October 6, 2005

RE: MOSAIC FERTILIZER, LLC, GREEN BAY FACILITY  
DEP FILE NO. 1050053-041-AC/PSD-FL-359  
MODIFICATION OF SOUTH AP AND NORTH MAP/DAP PLANTS

Re: DEP File No. 1050053-041-AC (PSD-FL-359)  
Green Bay Facility – Modification of South AP and North MAP/DAP Plants

Figure 2-3  
 South AP Fertilizer Plant  
 Process Flow Diagram  
 Mosaic Green Bay

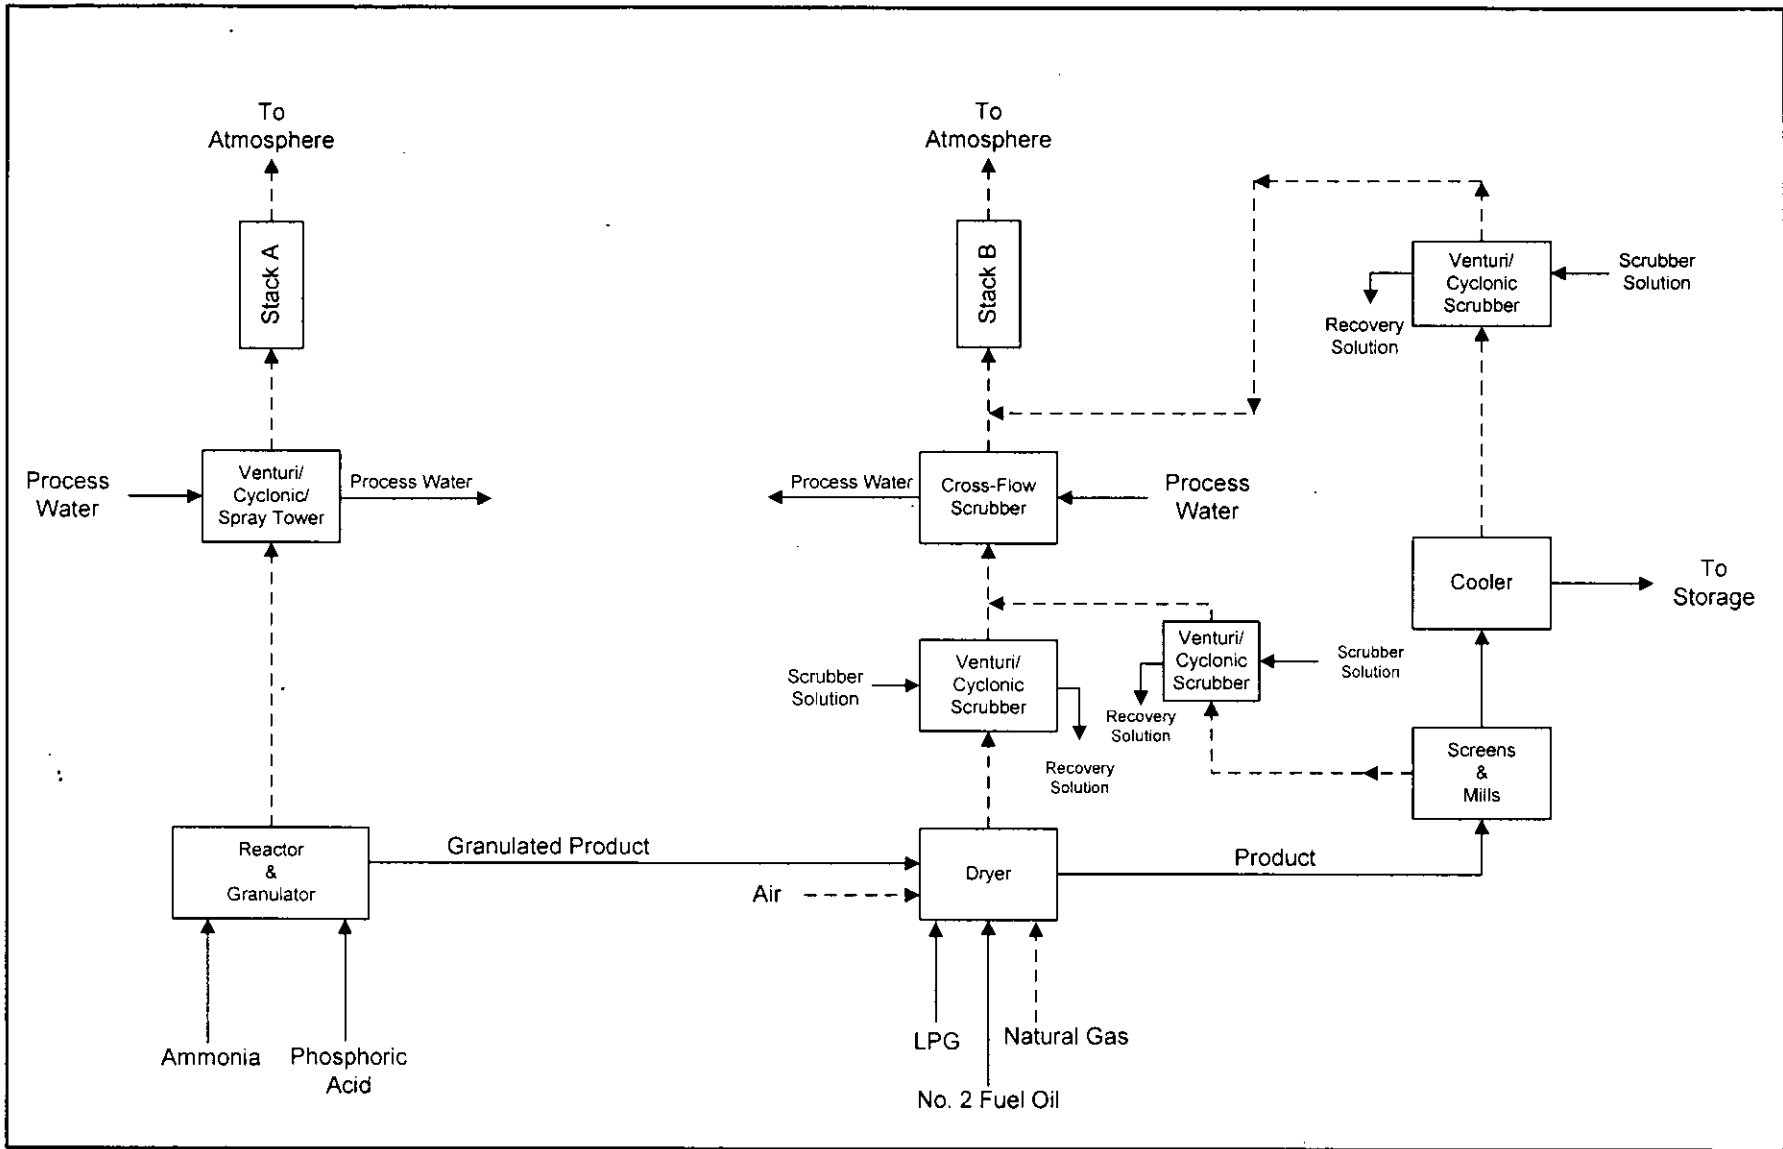
1. **E. U. 007 - Refer to Page 15, Emission Unit Control Equipment, and Figure 2-3, Process Flow Diagram: Equipment types and numbers do not tally in these two documents. Also, these information do not tally with the recently submitted Title V Renewal Application (Title V Renewal - Final, was issued on 8/26/05). Please ask for information of each actual control equipment in place, its description with the manufacturer information, for proper tracking.**

**Response:** Page 15, Emission Unit Control Equipment, and Figure 2-3, Process Flow Diagram, equipment types and numbers appear to be consistent in this application. As stated in the response to FDEP Question #1 above, the R/G scrubber is venturi/cyclonic scrubber with a spray tower. Therefore, there are four (4) venturi/cyclonic scrubbers, with one (1) wet scrubber (the cross-flow scrubber). A revised flow diagram is attached to be clearer in this regard. A modification for the Title V permit will be submitted to correct this information. The description of scrubbing equipment as provided in the application is correct and due to the age of the equipment, manufacturer information is not available.

Figure 2-4  
North AP Fertilizer Plant  
Process Flow Diagram  
Mosaic Green Bay

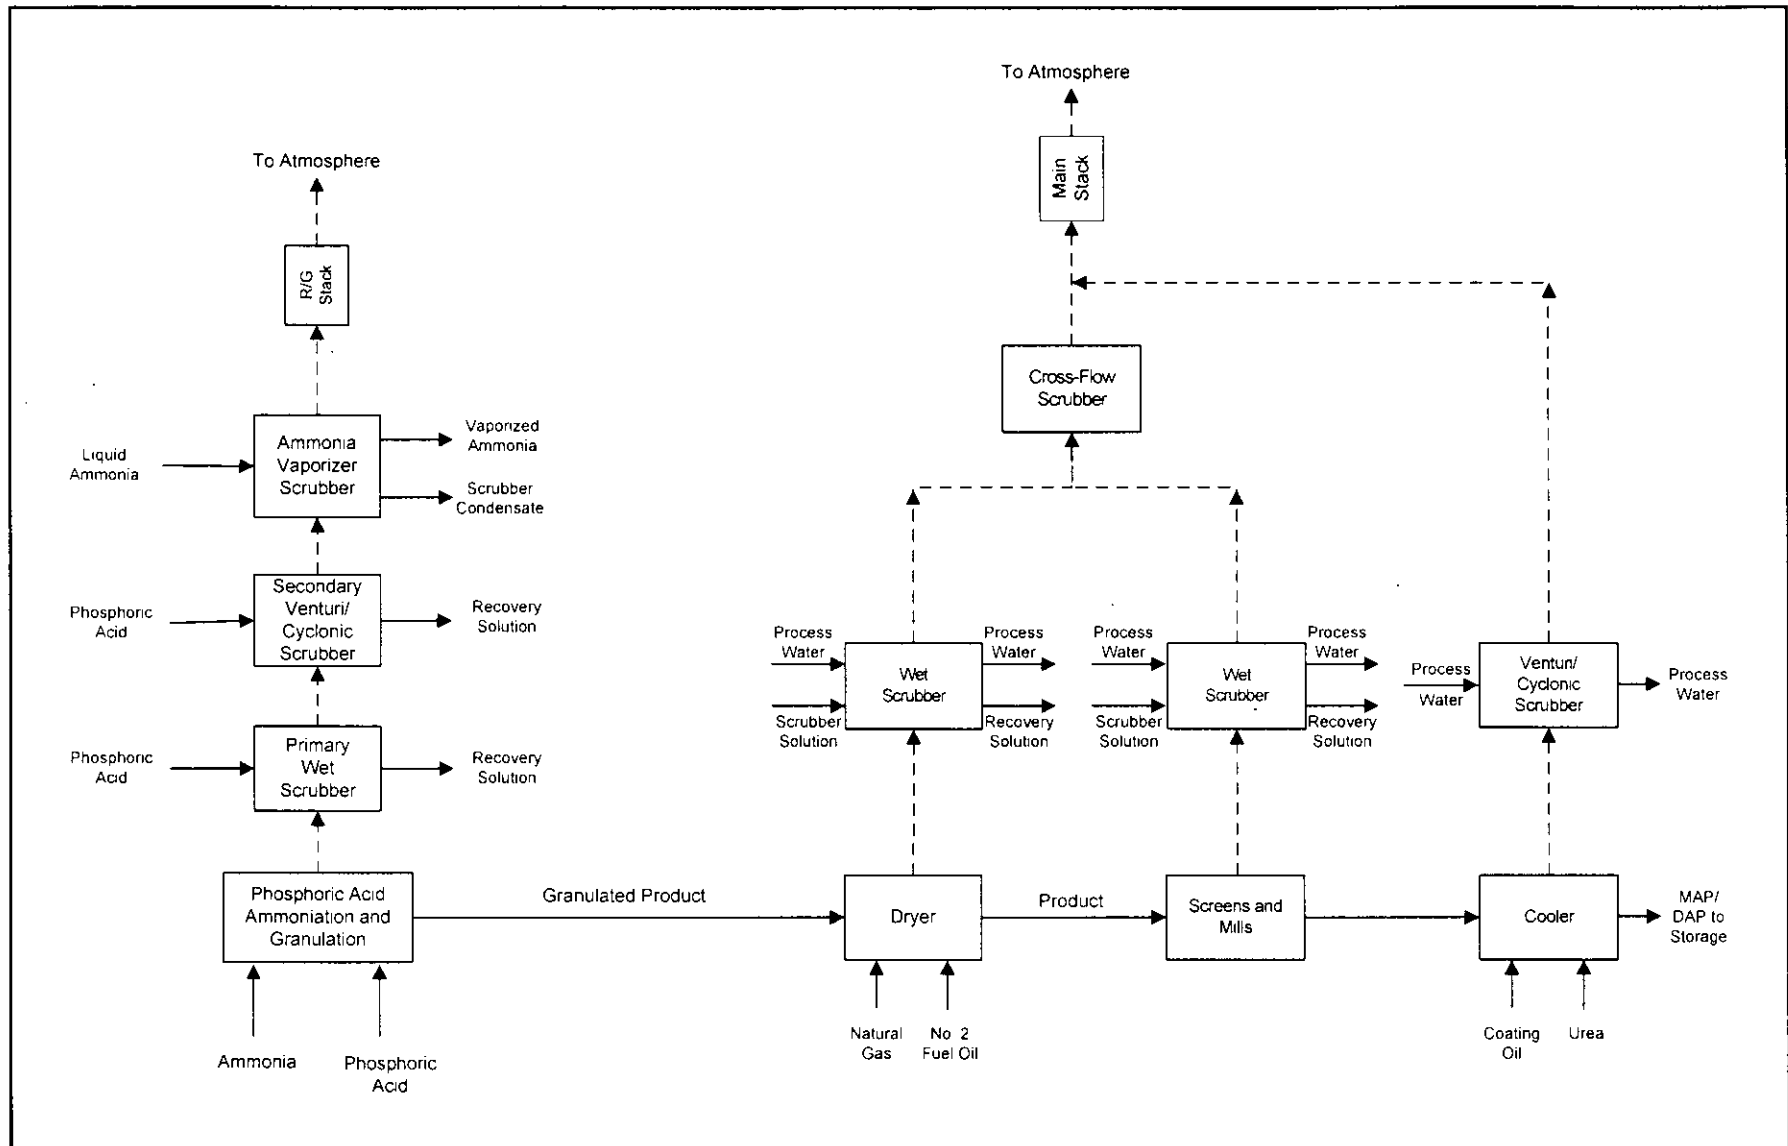
2. **Figure 2-4 of the application indicates a primary wet scrubber for the North MAP/DAP Plant R/G system. Please indicate if this is a separate scrubber followed by a venturi/cyclonic and a tail-gas scrubber. When was the primary wet scrubber installed at this plant?**

2. **E. U. 029 - Refer to Page 15, Emission Unit Control Equipment, and Figure 2-4, Process Flow Diagram: Equipment types and numbers do not tally in these two documents. Also, these information do not tally with the recently submitted Title V Renewal Application (Title V Renewal - Final, was issued on 8/26/05). Please ask for information of each actual control equipment in place, its description with the manufacturer information, for proper tracking.**

**Response:** The primary wet scrubber on the North MAP/DAP Plant is a separate scrubber. It is followed by a venturi/cyclonic scrubber as the secondary scrubber and then by a third scrubber, which is an ammonia vaporizer scrubber. The primary wet scrubber was installed in 1992.

**Response:** Page 15, Emission Unit Control Equipment, and Figure 2-4, Process Flow Diagram, equipment types and numbers should be revised. Page 15 should indicate one ammonia vaporizer, two venturi/cyclonic scrubbers, and four wet scrubbers. The appropriately revised pages are attached. The primary Reactor/Granulator Scrubber is a wet scrubber, the Secondary RG Scrubber is a venturi/cyclonic scrubber, the Dryer Scrubber is a wet scrubber, the Screen and Mill scrubber is a wet scrubber, the Cooler Venturi Acid Scrubber is a venturi/cyclonic scrubber, and the Cross-Flow Scrubber is a wet scrubber.
